REMARKS

In the Office Action¹ ("OA") mailed January 27, 2006, the Examiner objected to the drawings. Specifically, the Examiner stated that Figs. 1 and 2 "should be designated by a legend such as --Prior Art-- because only that which is old is illustrated" (OA at page 2, lines 7-14). Accordingly, Applicants correct Figs. 1 and 2, as suggested by the Examiner.

FIG. 1

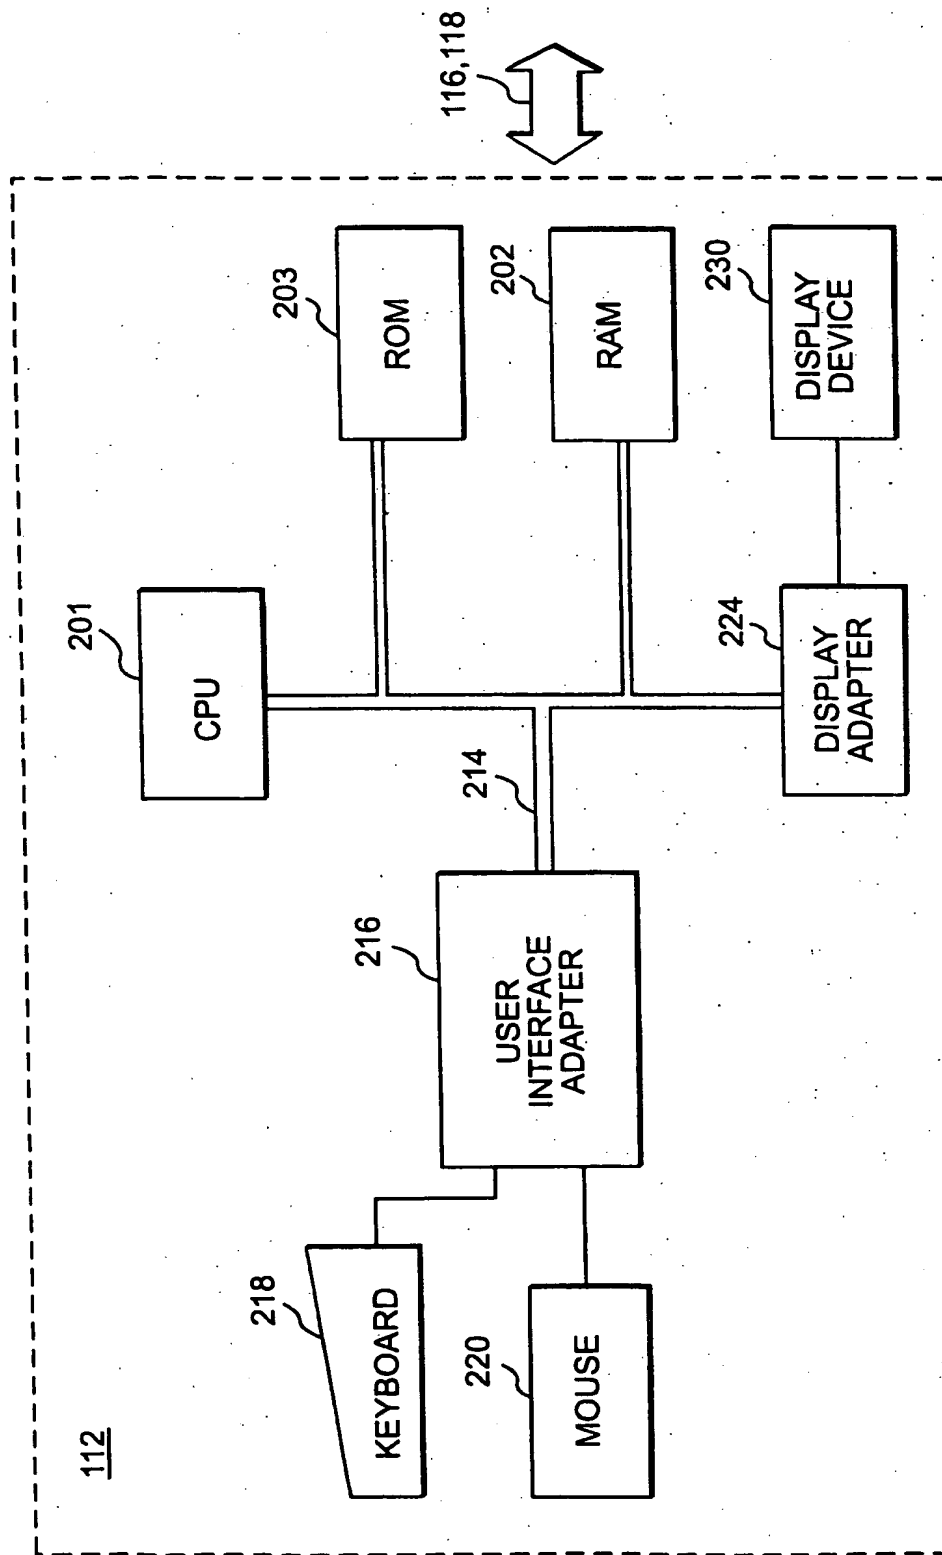
The attached sheets of drawings include changes to Figs. 1 and 2 by adding notations as requested by the Examiner.

-- PRIOR ART --
